CITY OF West Linn

Memorandum

Date: March 20, 2023
To: Mayor Bialostosky and City Council
From: Darren Wyss, Planning Manager
Subject: AP-23-01 Public Comments

Subject: Additional Written Comments provided pursuant to the Continuance of the Council Hearing for Appeal AP-23-01, Regarding the Planning Manager Decision for WAP-22-02, a Water Resource Area Permit for 19679 Wildwood Drive

Screenshot of a portion of Sheet 3/25, As-Built Drawing Set, Hidden Springs Ranch No. 6, 1981.

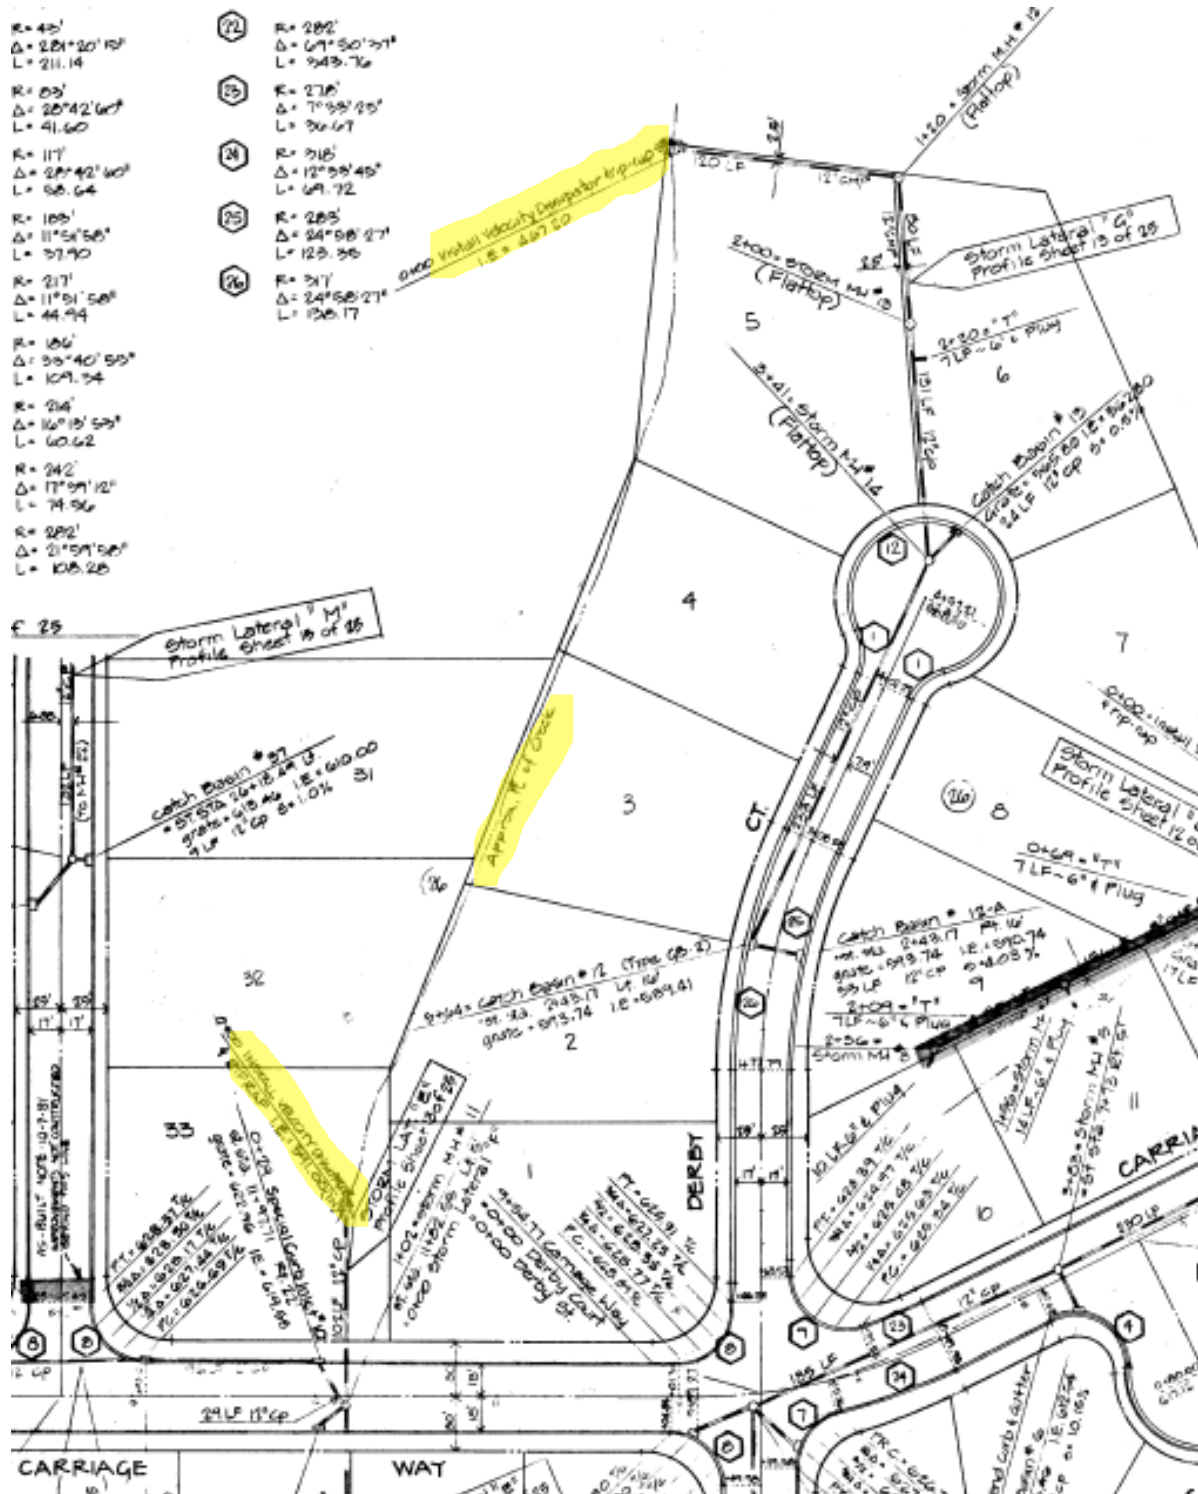
Below is a screenshot of a portion of Sheet 3/25 from the Hidden Springs Ranch No. 6 as-built drawing set. The storm lateral from the end of Derby Court runs along the east and north sides of Lot 5 to Robin Creek. The approximate centerline of the creek is illustrated on the as-built drawing. The highlighted note on the upper left-hand portion of the screenshot references the installation of the velocity dissipator and rip-rap at the northwest corner of Lot 5. This location also corresponds to the southeast corner of the Applicant’s property.

Further upstream on Robin Creek (i.e., to the south), a second velocity dissipator and rip-rap structure was installed for the discharge of stormwater from Carriage Way and Lexington Terrace. See the highlighted note on the lower left-hand portion of the figure below.

Neither the Natural Resource Assessment or the Planning Manager Decision presented information regarding these velocity dissipators and rip-rap structures, either as site visit observations or as references to the as-built drawing sets. Consequently, the impact of heavy

stormwater discharge from Derby Court, Carriage Way, and Lexington Terrace to the reach of Robin Creek running through the Applicant's property has not been considered.
